# Planning Report

## 3 Palm's Restaurant – Patio Accessory Use – 108 N. High Street

Agenda Item	2
Case Number	17-021 ARB-MPR
Proposal	Review of a patio, exterior modifications, and related site improvements to a previously approved structure, Building Z of the Bridge Park Development, West.
Request	Review and approval of a Minor Project Review under the provisions of Zoning Code Sections 153.066.
Site Location	Located on the east side of High Street, north of the intersection with Bridge Street.
Applicant	Dublin West A, LLC; Nelson Yoder, Crawford-Hoying
Case Manager	Lori Burchett, AICP, Planner II   614.410.4656   <a href="mailto:lburchett@dublin.oh.us">lburchett@dublin.oh.us</a>
ART Recommendation	Approval of a Minor Project Review with 1 Condition.  1) That the outdoor furniture coordinates with the design of the interior furnishings in a similar and high-quality design.

17-021ARB-MPR  
Minor Project Review  
3 Palms Restaurant Patio  
108 North High Street

### Proposed Patio Design (From N. High Street)

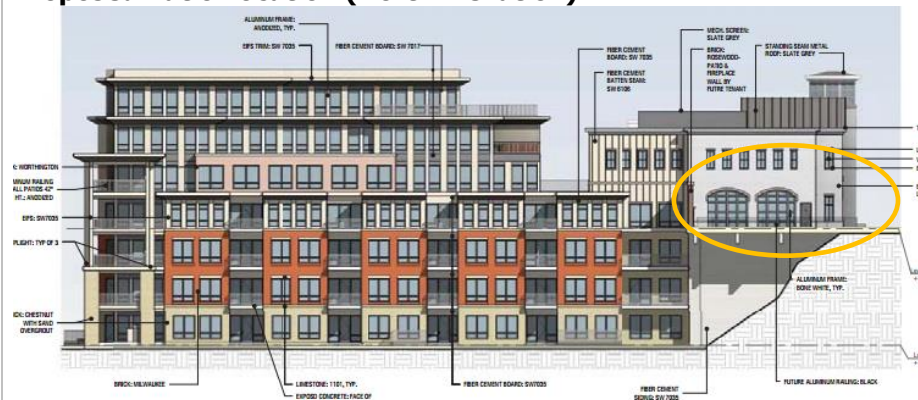
e) Coordination and Integration of Building and Structures	<b>Criterion Met with conditions:</b> The proposed patio is integrated into the main structure with coordinated design elements including material and color.

<b>ART Recommendation    Minor Project Review – Accessory Use/Addition</b>	
Approval	The proposed patio meet the requirements of the Zoning Code and is consistent with the character of the Bridge Street District as applied to existing structures. Approval of this application is recommended with one condition.
Condition	1) That the outdoor furniture coordinates with the design of the interior furnishings in a similar and high-quality design.

- 1) That the outdoor furniture coordinates with the design of the interior furnishings in a similar and high-quality design.
